Groundwater Review Summary Form

Application # G- 18350

GW Reviewer M. Thomas Date Review Completed: 9/30/16

TO: Water Rights Section Date 9/29/16
 FROM: Groundwater Section Michael J Thoma
Reviewer's Name
 SUBJECT: Application G- 18350 Supersedes review of _____
Date of Review(s)

Well Location Map

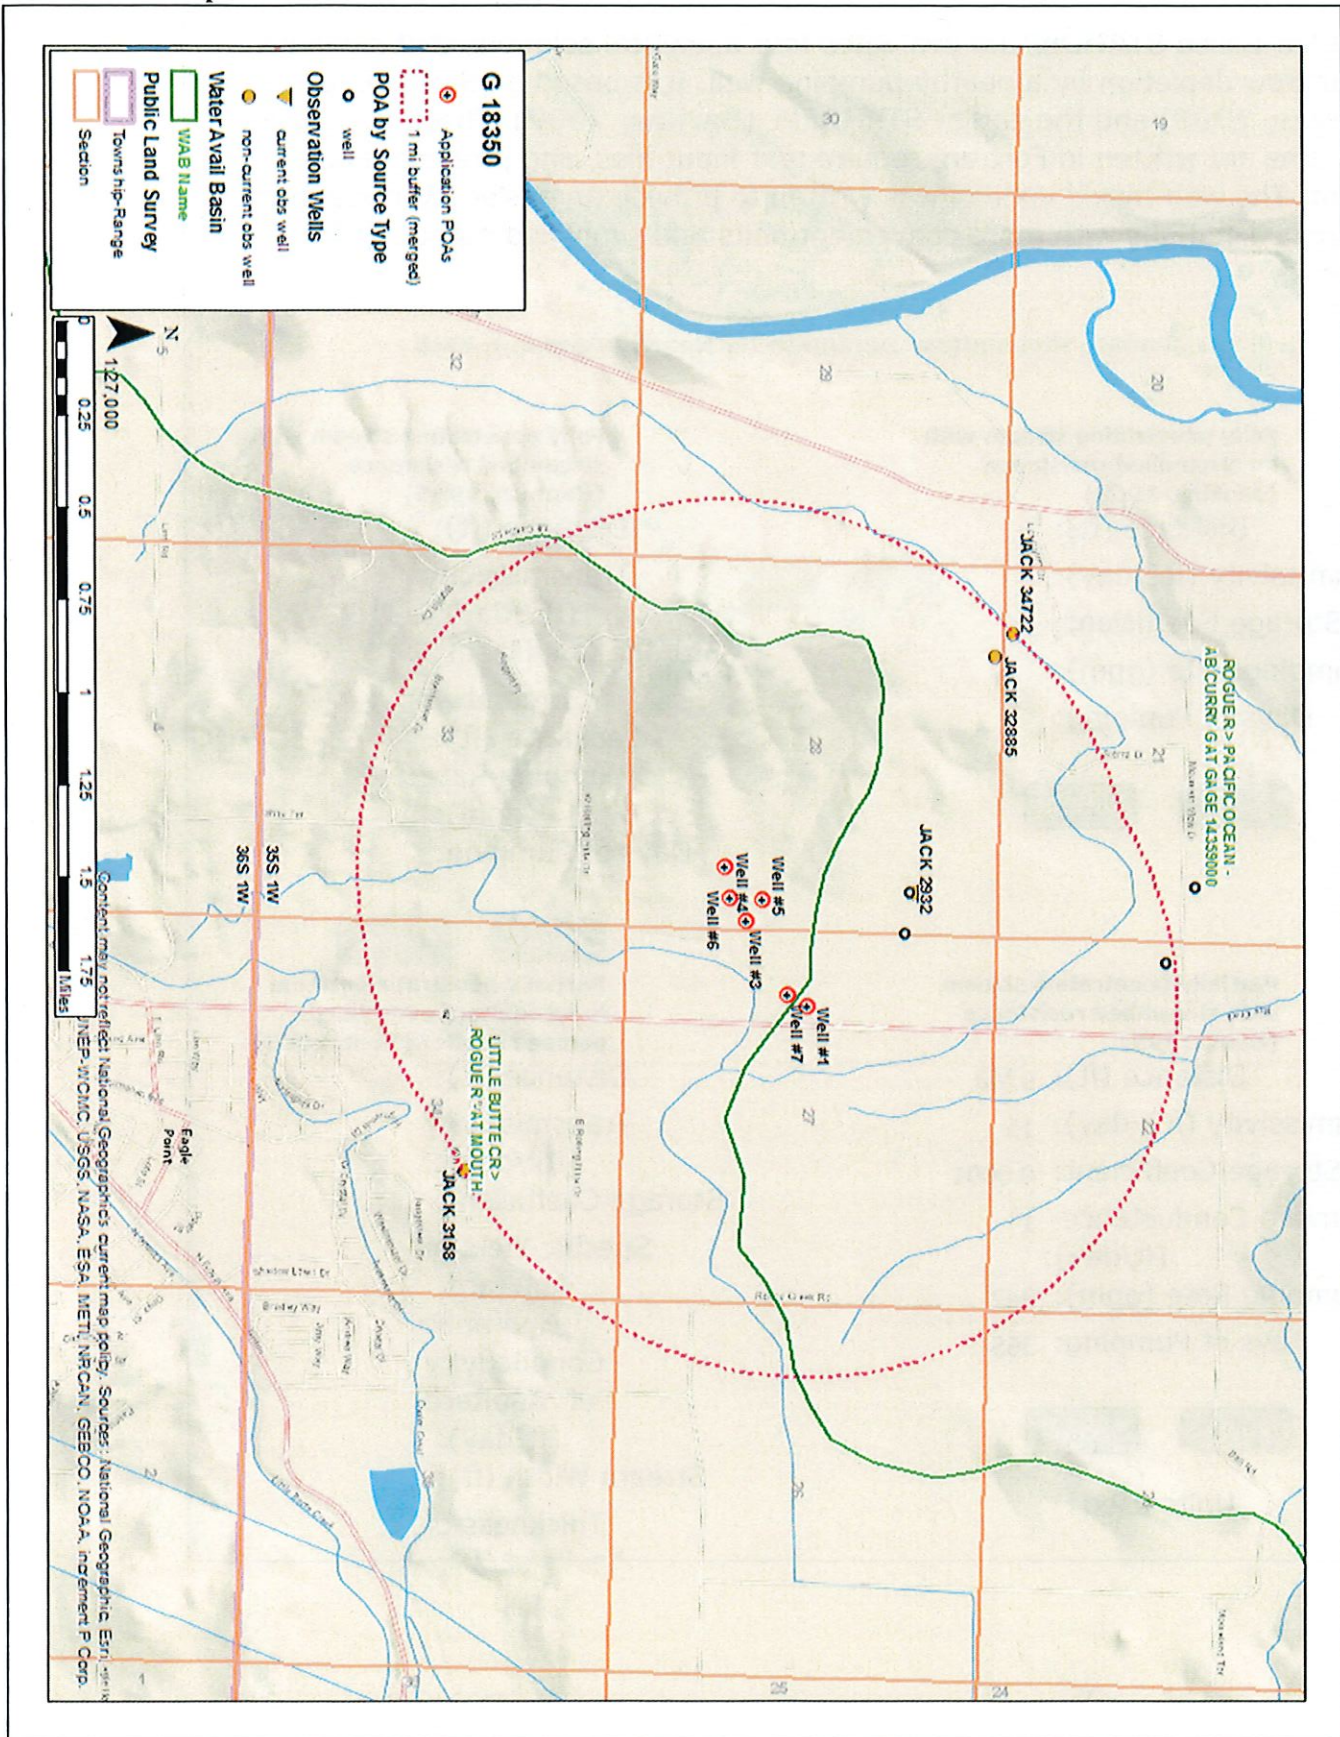
A4. **Comments:** *SWLs are provided by the applicant but do not give a specific date, only a year (1998 for wells #1, #2, #4, #5 and 2016 for wells #3 and #6). SWLs reported on driller's logs range between approx. 10 and 50 ft for the wells listed on the application and between approx. 10 and 40 for most wells drilled in the area (see attached plots)

Well #1 is located barely within the Rogue River WAB. However, the topography of the area across the basin divide is very flat and there is large rise (Long Mountain) located directly west of Well #1 and between the wells and the Rogue River. So although Well #1 is within the Rogue River WAB, hydraulic connection to the Rogue River will be small in comparison to connection to Little Butte Cr due to the topography so only Little Butte Cr. was evaluated for PSI.
